GFA AD 559

GFA AIRWORTHINESS DIRECTIVE

Jamming of elevator control.

FLIGHT CONTROL – INSPECTION OF ELEVATOR DRIVING ROD UNDER HORIZONTAL CONSOLE

Figure #1 (Ref.: fig 16- Parts Catalog)

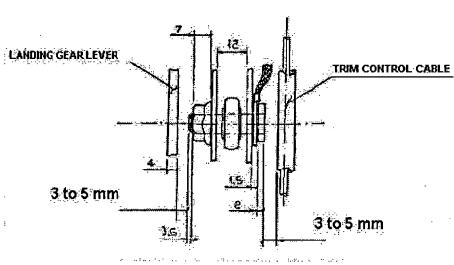
- 2.1 Place the airplane on jacks.
- 2.2 Remove the cover of horizontal console (Parts Catalog fig. 32 item 14).
- 2.3 Retract the landing gear.
- 2.4 Push the control stick (elevator driving) slowly foward and check if the gap between landing gear lever (in retracted and caged position) and nut that fix the terminal rod of elevator driving is about 3 to 5 mm in accordance with detail "A" of figure #1.

- 2.5 Check if the gap between screw head and the trim cable cap is about 3 to 5 mm in accordance with detail "A" of figure #1.
- 2.6 Check the installation position of grounding cable; if the grounding cable washer is installed close to nut, remove and install close to screw head; check the gaps again.

2.8 If no interference or warping is found in the main landing gear lever and the gaps are in accordance with dimensions specified in figures in attached, the airplane can be approved to flight.

DETAIL "B" - BEARING FITTING

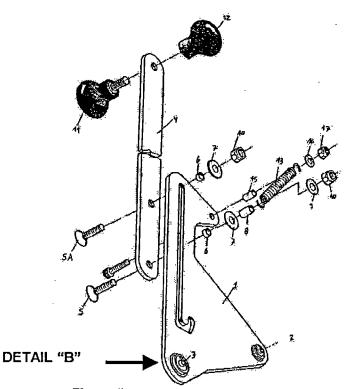
- 2.7 Check if there are signs of chafing of nut (that fix the terminal of rod of elevator driving) in the landing gear lever P/N 15316; if there are signs of chafing, remove the support guide P/N 15315 and inspect its flatness and if there is gap in the bearing fitting (See detail B of figure #2). Replace non conformance parts.
